Addendum #3

T25-53 - Changeroom Alterations at Pine Ridge S.S.

Architectural Addendum 01

Addendum No. ME-1

GROUND FLOOR SOUTH CHANGE ROOMS - DEMOLTION PLUMBING

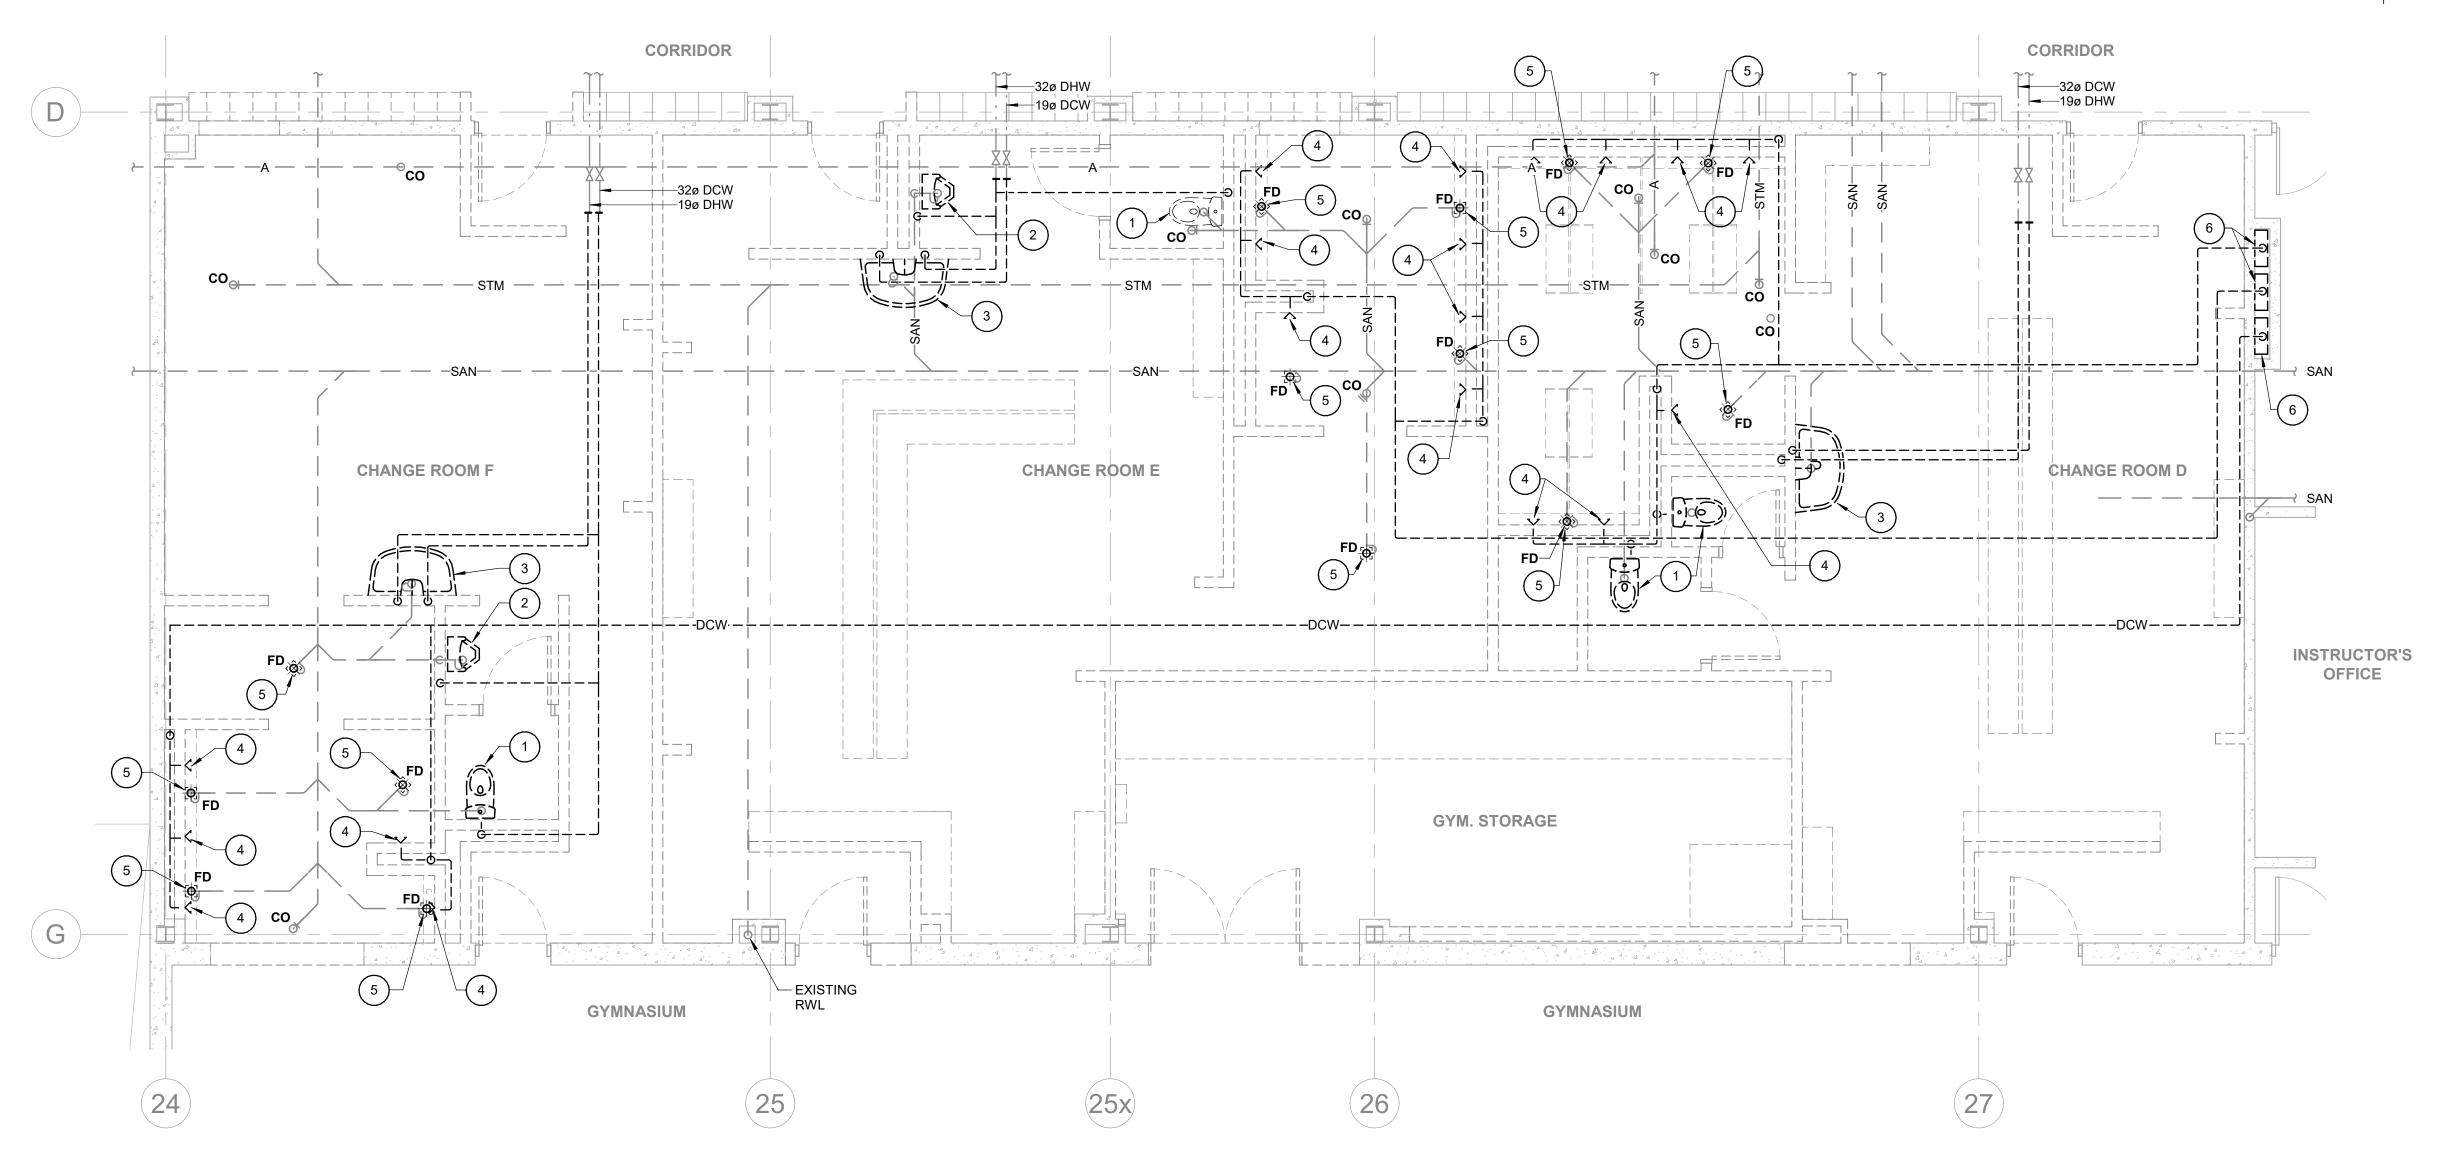
- 1.1 Drawing PD101
 - .1 Refer to revised Demo Plumbing Drawing PD101 with corrected storm and sanitary locations.
- 1.2 Drawing P-101
 - .1 Refer to revised New Plumbing Drawing P-101 with corrected storm sanitary main locations.

GROUND FLOOR - NEW LIGHTING LAYOUT

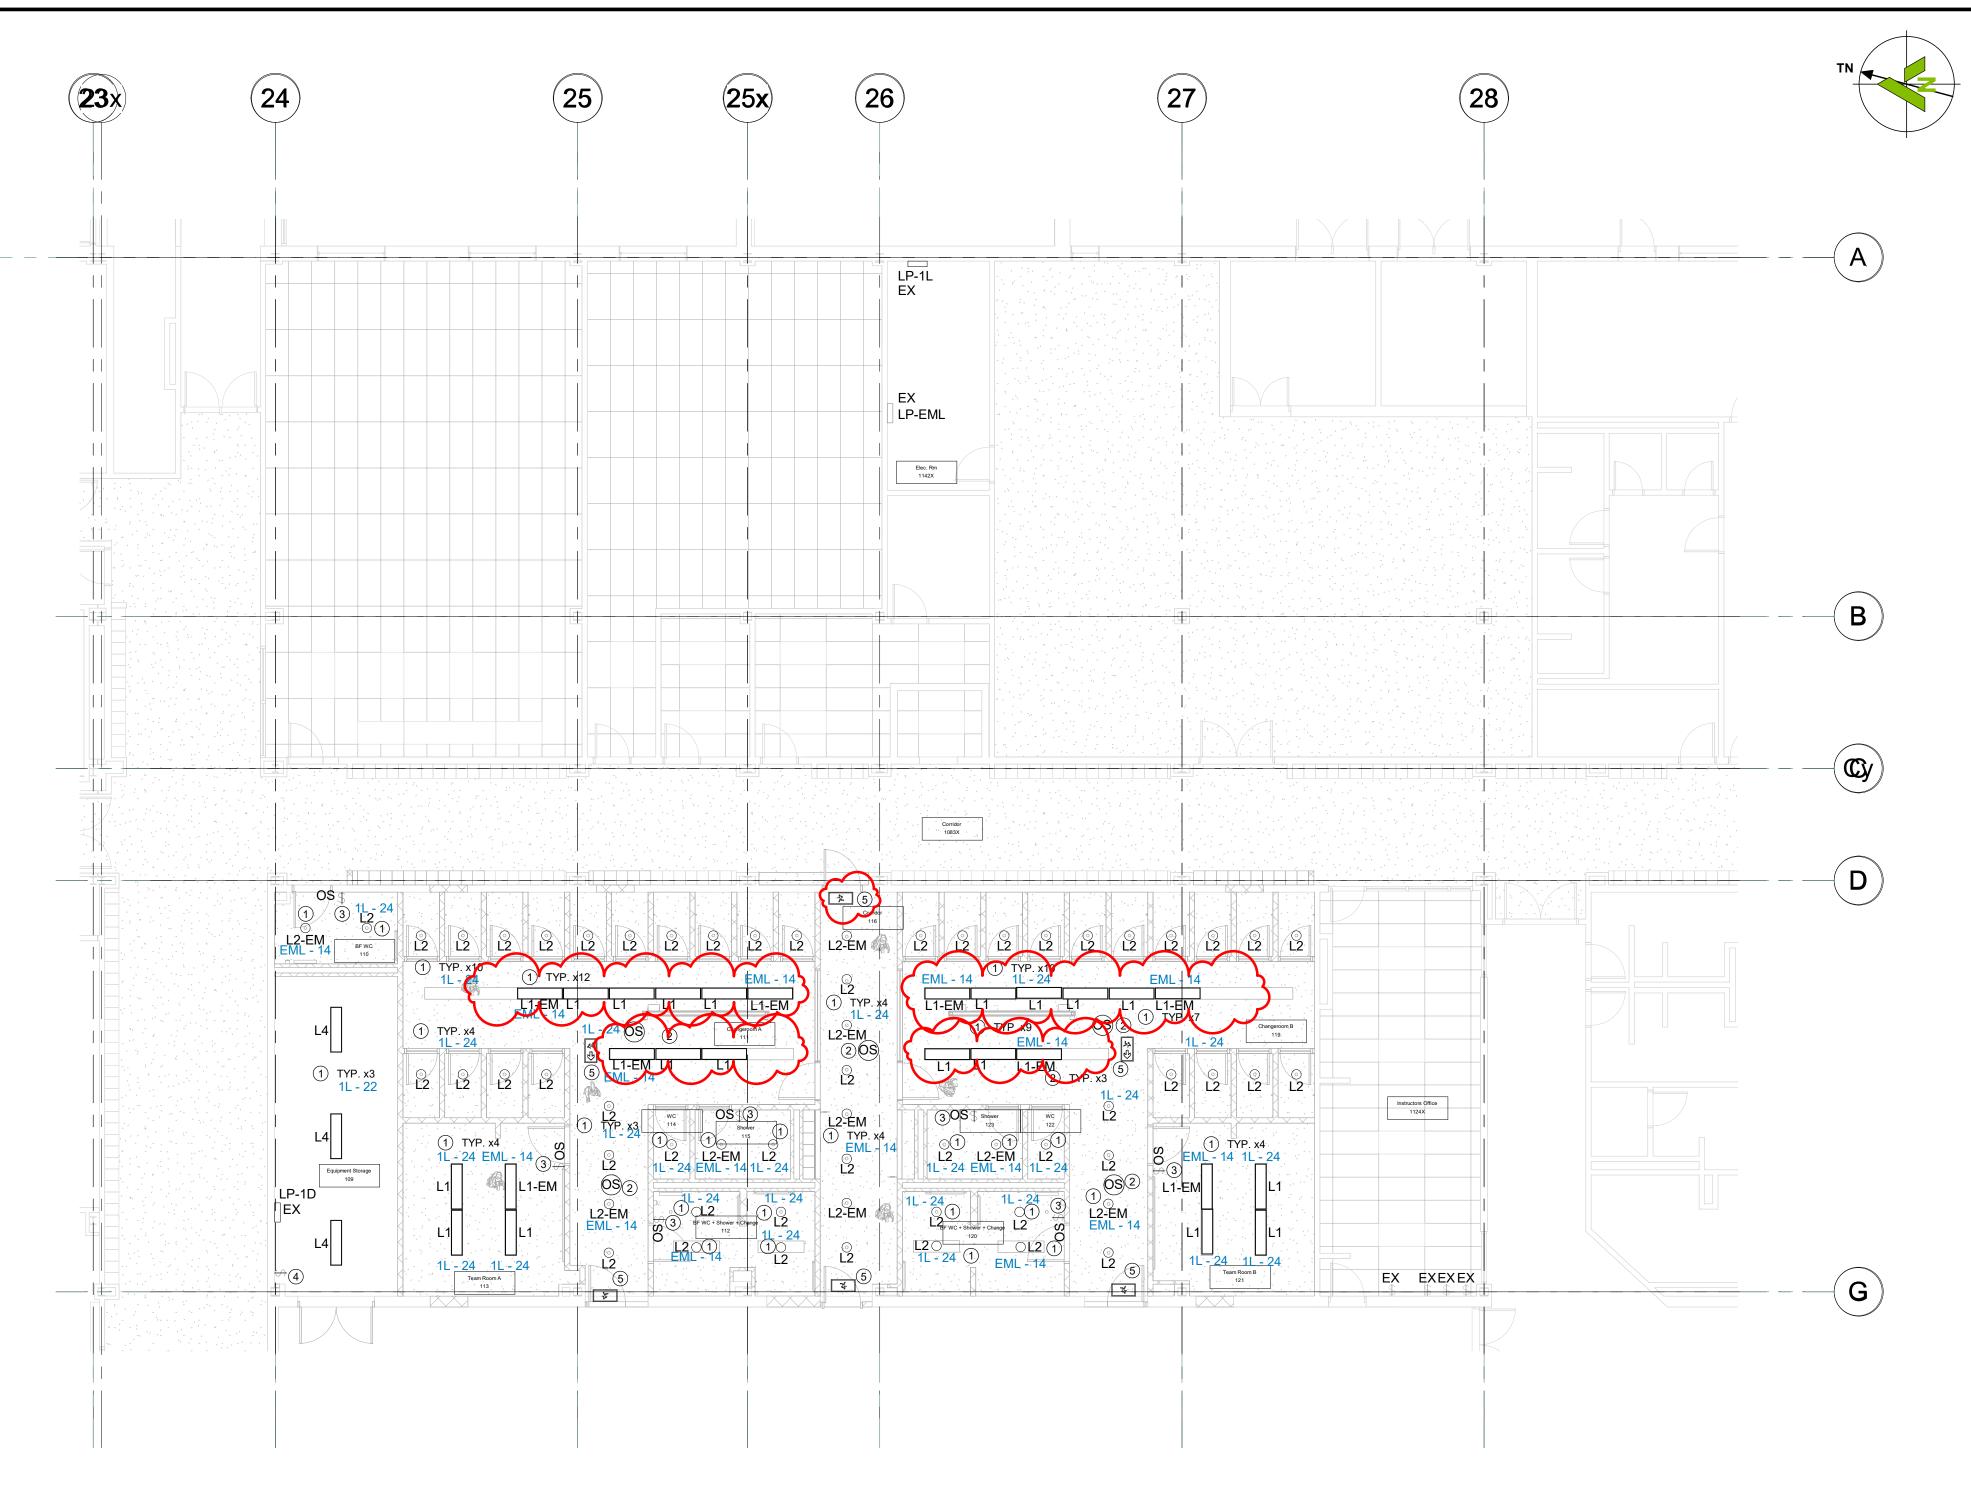
- 2.1 Drawing E-102
 - .1 Provide three (3) additional L1 fixtures in Changeroom A.
 - .2 Provide three (3) additional L1 fixtures in Changeroom B.
 - .3 Provide one additional exit sign in Corridor 116 above north door.
- 2.2 Drawing E-002
 - .1 Delete Fire Alarm Scope of Work Item 4.
 - .2 Delete Fire Alarm Scope of Work Item 9.
 - .3 Delete Fire Alarm Scope of Work Item 12.
 - .4 Delete Fire Alarm Scope of Work Item 24 and 25.
 - .5 Add to Fire Alarm Scope of Work:
 - .1 New signal circuit to be provided and new addressable initiating circuit to be provided from FACP for new devices shown.
